ADDENDUM NO. 2 – RFB-463
Parking Garage Elevator Replacement at
Fairmont State University
Fairmont, WV

In accordance with AIA Document A701 Instructions to Bidders, Article 1, 1.1, the drawings and specifications for **Parking Garage Replacement at Fairmont State University**, as prepared by Tower Engineering and Williamson Shriver Architects, Inc., are hereby amended, and all changes (in either addition or deduction) which may result due to the following amendments shall be included in the bid.

PARKING GARAGE ELEVATOR REPLACEMENT AT FAIRMONT STATE UNIVERSITY

H101r

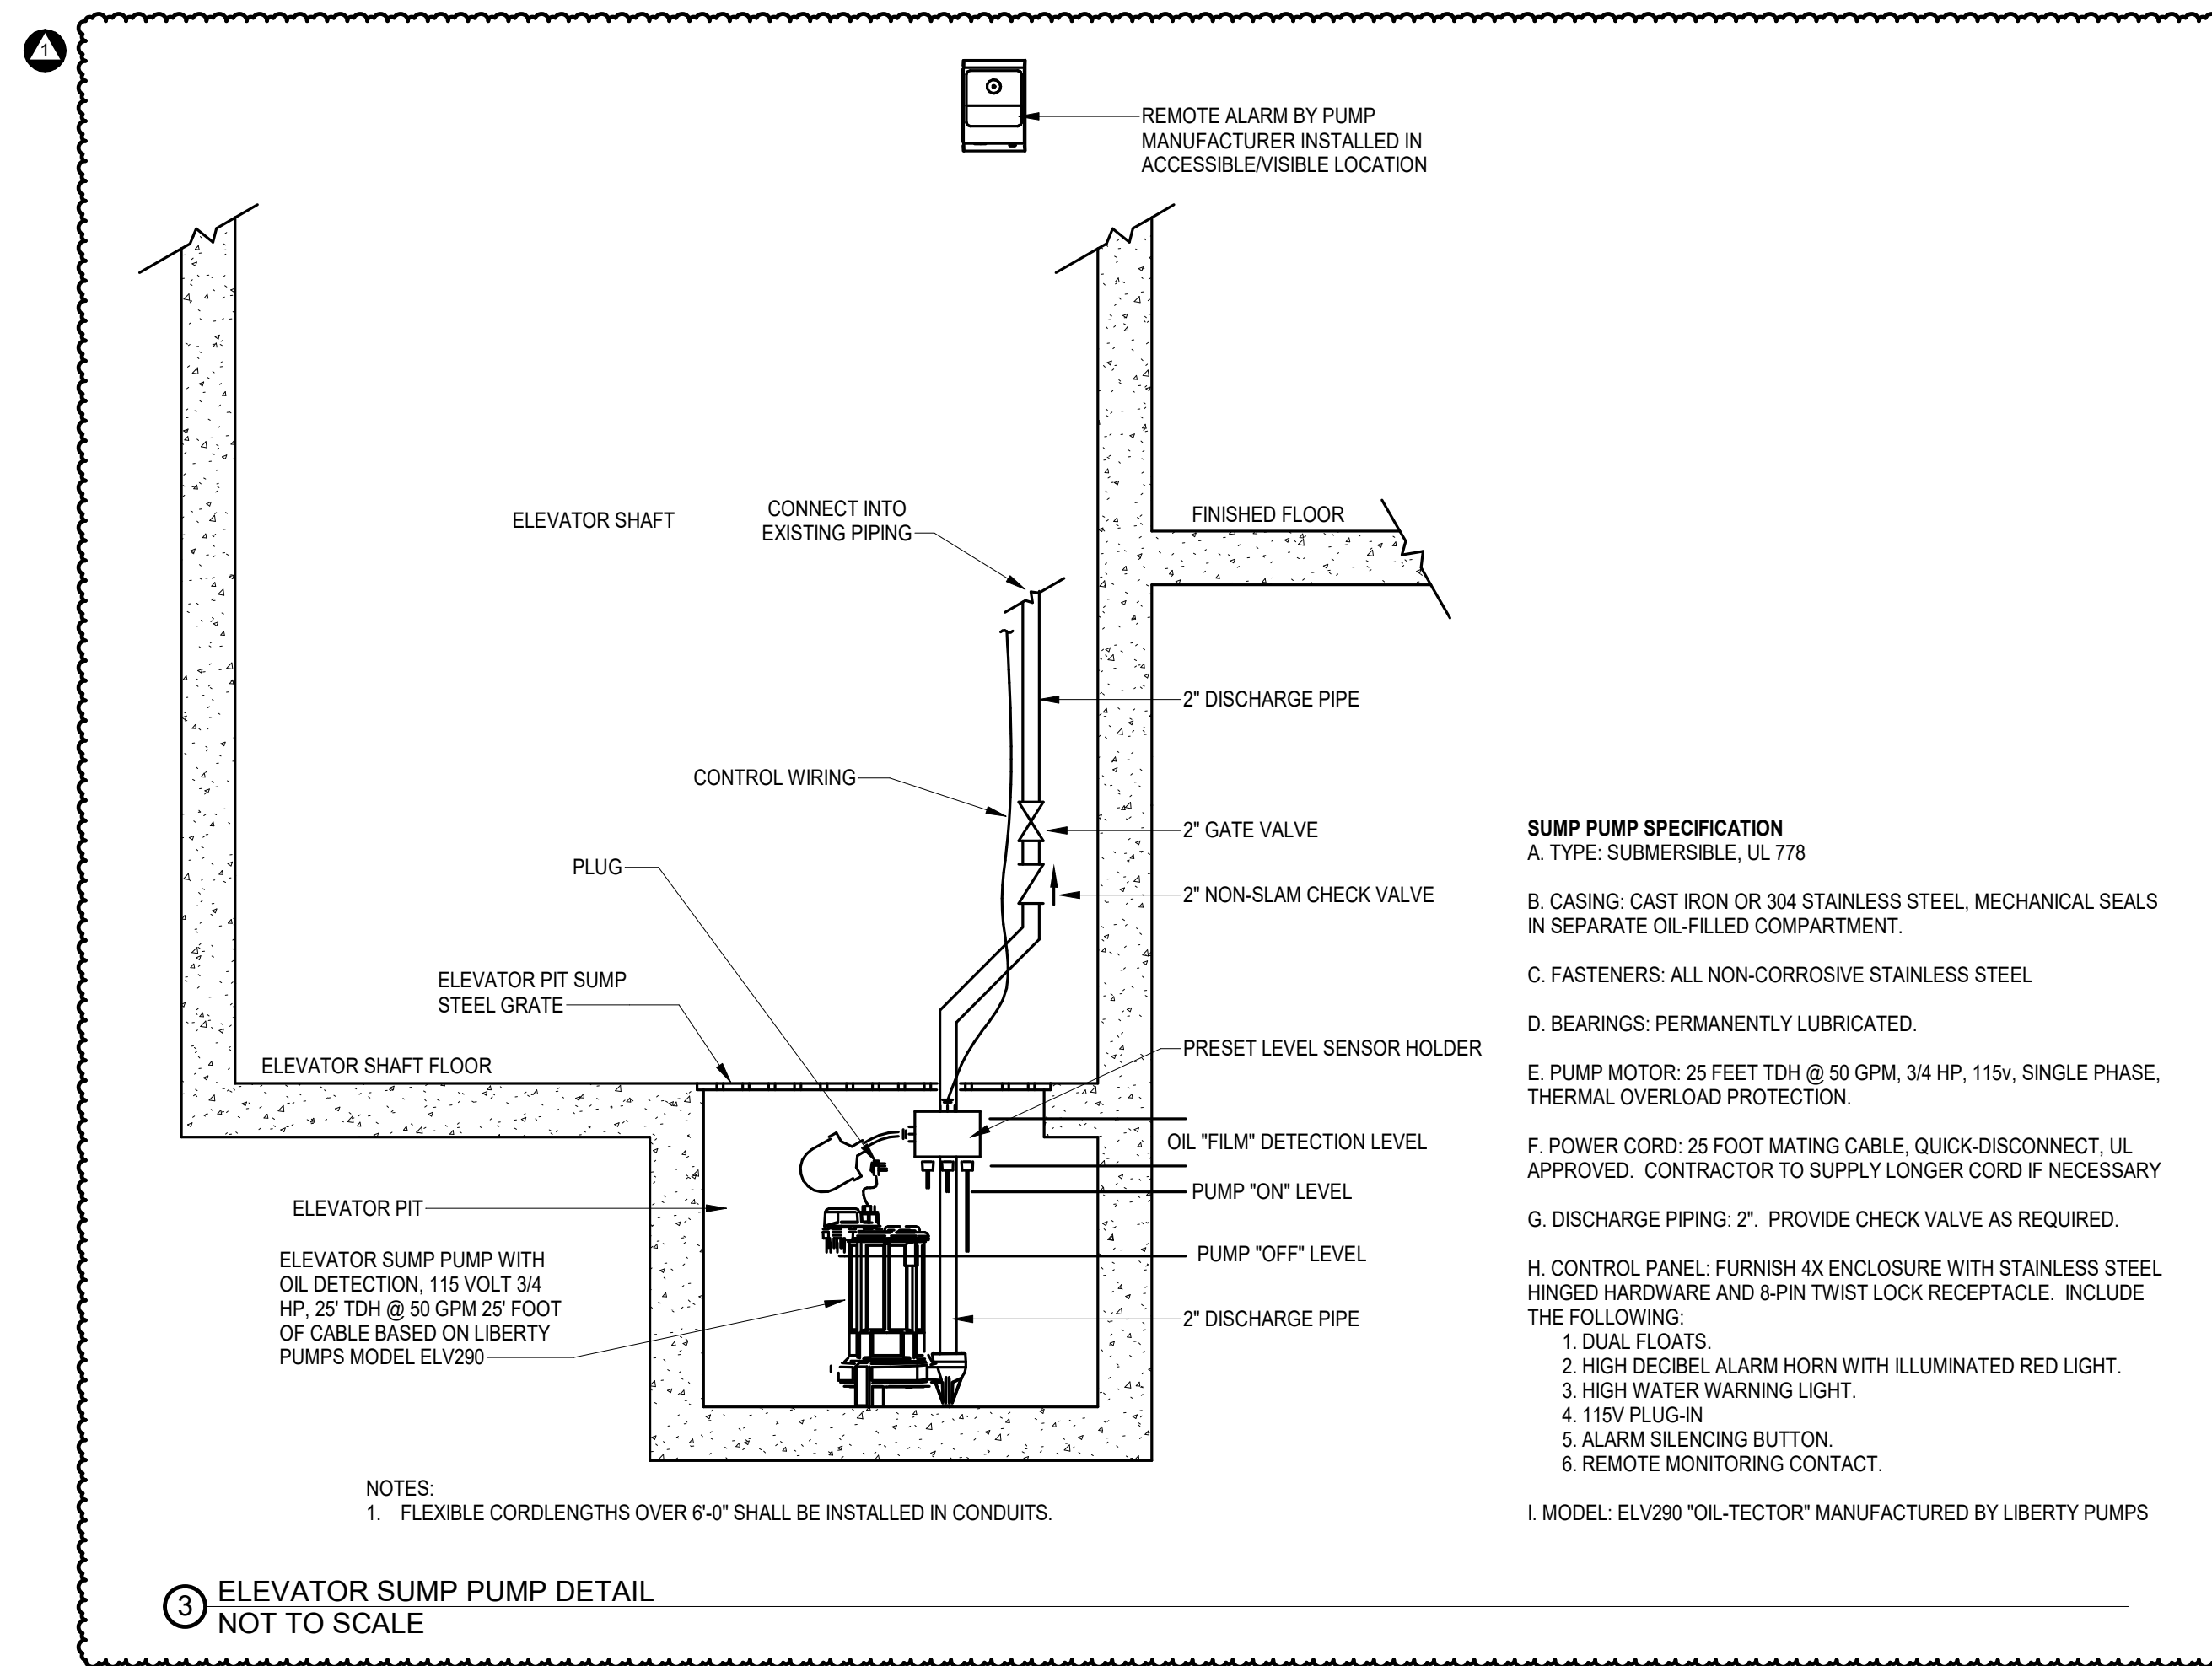
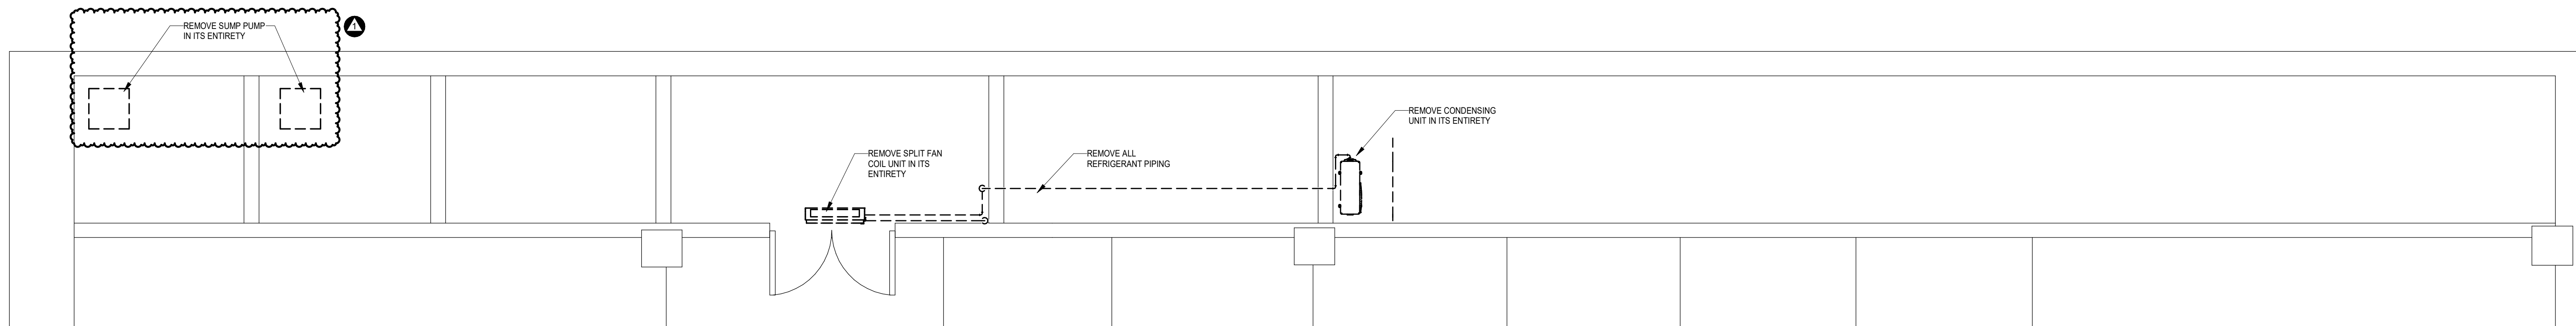
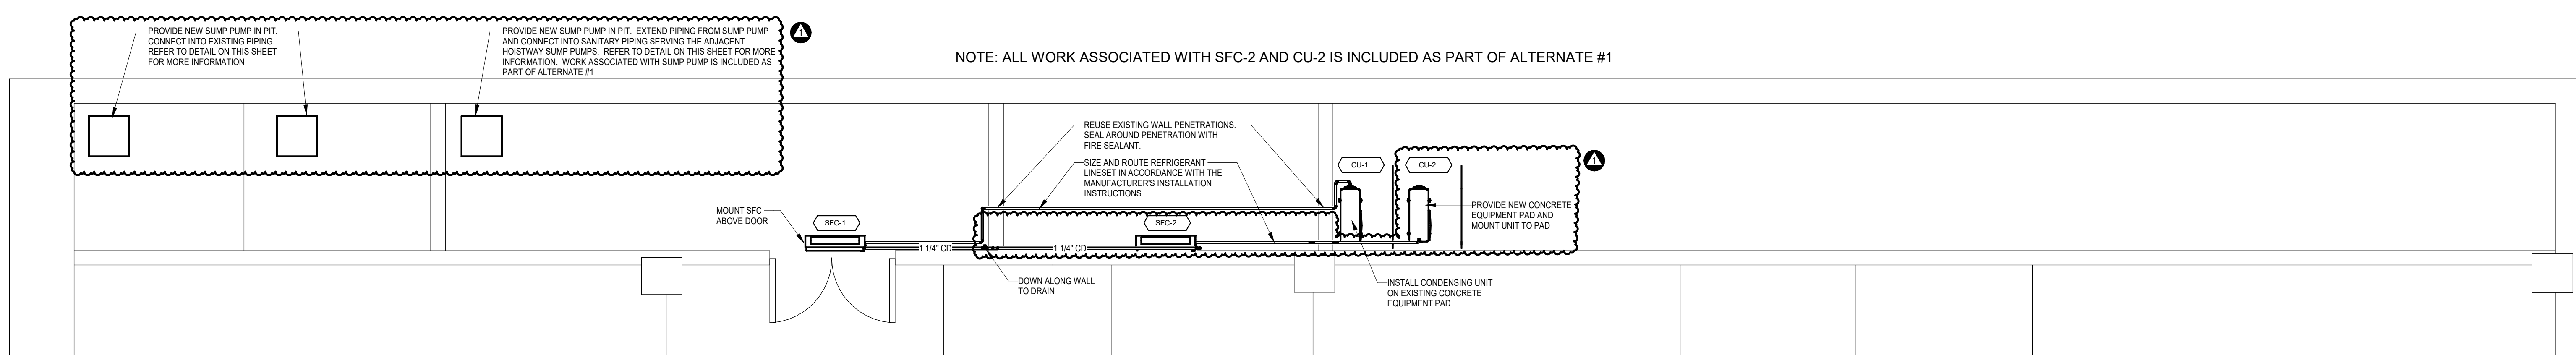
1. Is there a specification or a basis of design for the new sump pump?
Answer: Refer to the attached sheet H101r for more information.
2. Are there any additional details for the plumbing of the new sump pump?

Answer: Refer to the attached sheet H101r for more information.
3. Under alternate #1 the ground floor door is being removed for the new elevator, is there any work with this door under the base bid?

17. Please advise if we are to reuse existing sump pump discharge piping to new sump pump. If we are to replace pump discharge piping, please provide information to where we are to route piping on drawings as well as what the piping application is to be for work.

18. Please advise if the controls for split system are to be stand alone controls or if they are to be tied into an existing bas system. If they are to be tied into bas system please provide a bod.

Answer: Refer to revised H-101r included in this addendum.

Answer: Refer to revised H-101r included in this addendum.
